014/5039/DJ/SRJ

Royd Edge Mill, Meltham – Local Authority Land Contamination Technical Comments Response

Further to the planning consultation response email dated 3rd October 2024, relating to discharge of Conditions 7 & 8, we are writing to address comments made by Kirklees Council on your behalf.

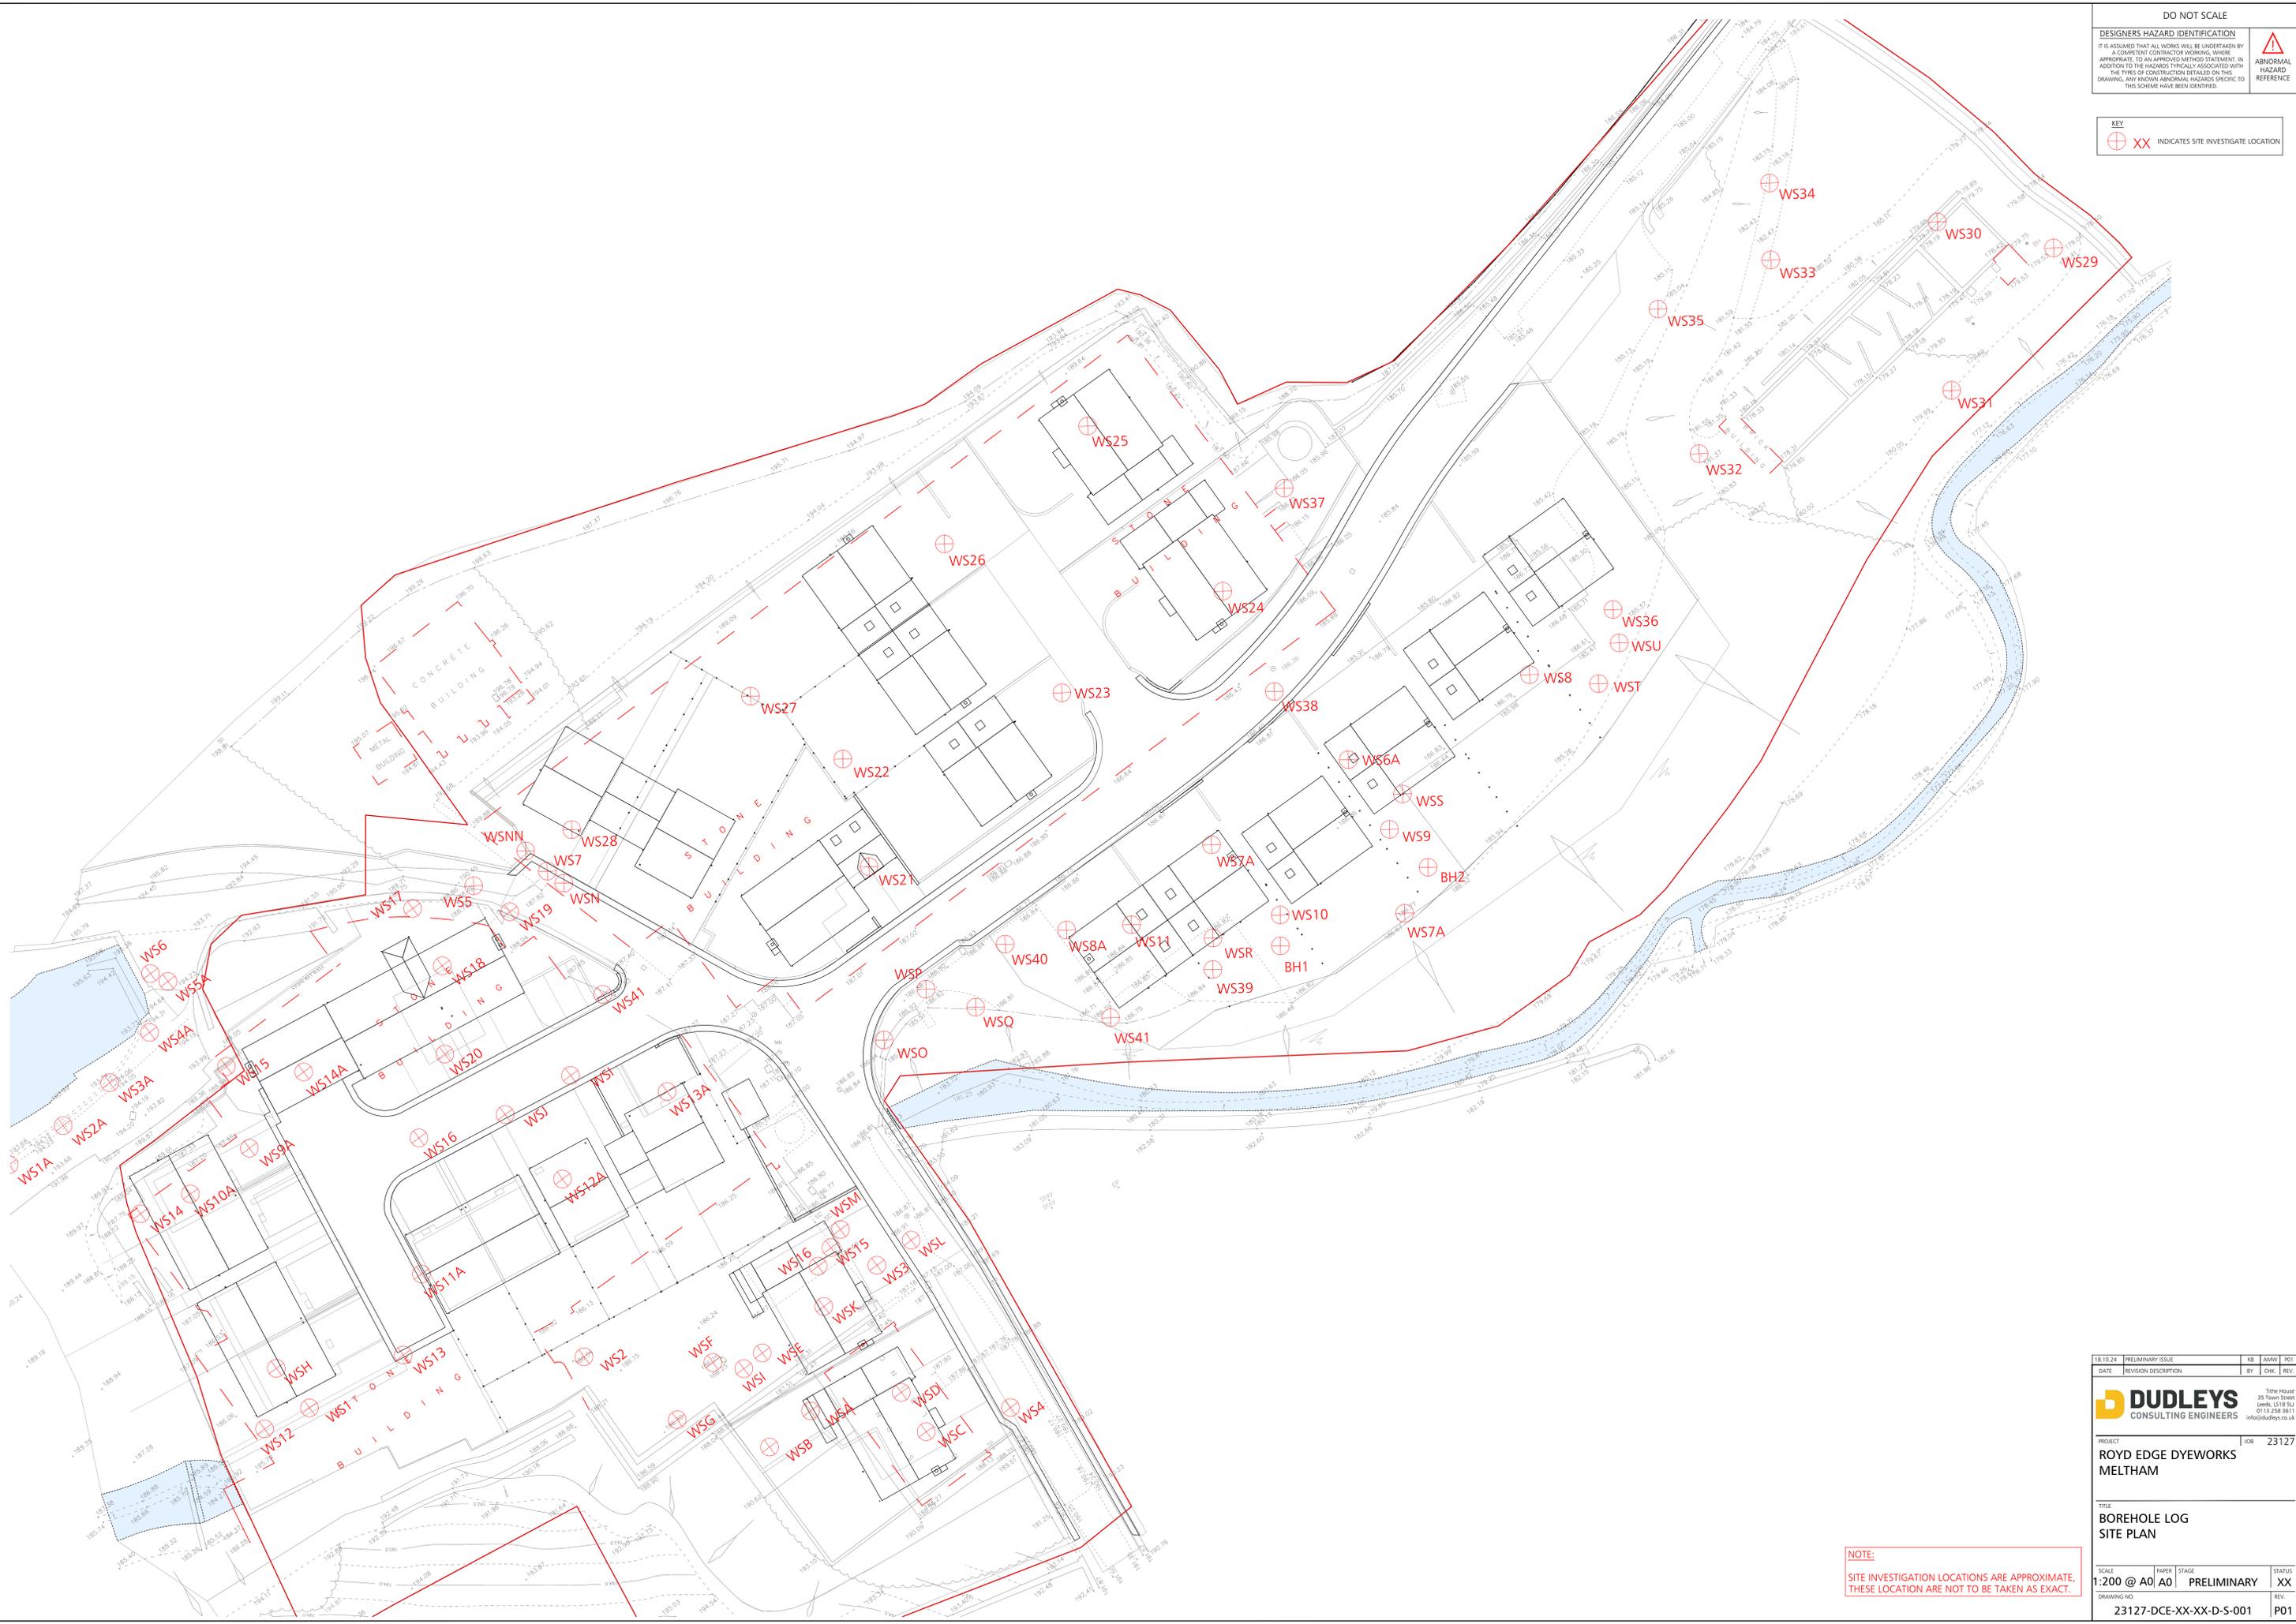
- 2) The revised report must ensure that naphthalene levels indicated in the WSG sample, along with a clear plan detailing the exact location of the WSG are included*

As per the Section 7.1 of the updated Interim Validation Report by Ashton Bennett borehole location WSG was within the previously (c.2011) remediated Area 4. This area was subject to excavation to 0.5m of the existing ground level at the time followed by disposal of arisings to landfill. The area was rechecked for signs of contamination by Ashton Bennett. Further to this the garden areas of these plots (and all plots on site where made ground is still present at the surface). These plots will therefore be covered with a 600mm clean cover system comprising 300mm virgin quarried stone and 300mm topsoil with a geotextile high visibility marker layer at the base. Lithos are in the process of validating these cover systems in terms of depths and also assessing the quality of soils (visually and chemical testing) and virgin quarried stone (visually checking quality) used within the cover system.

A plan of the approximate borehole positions overlaid with the proposed plot layout has been compiled by the developers consulting engineers (Dudleys) based on the Ashton Bennett plans and is appended to this letter.
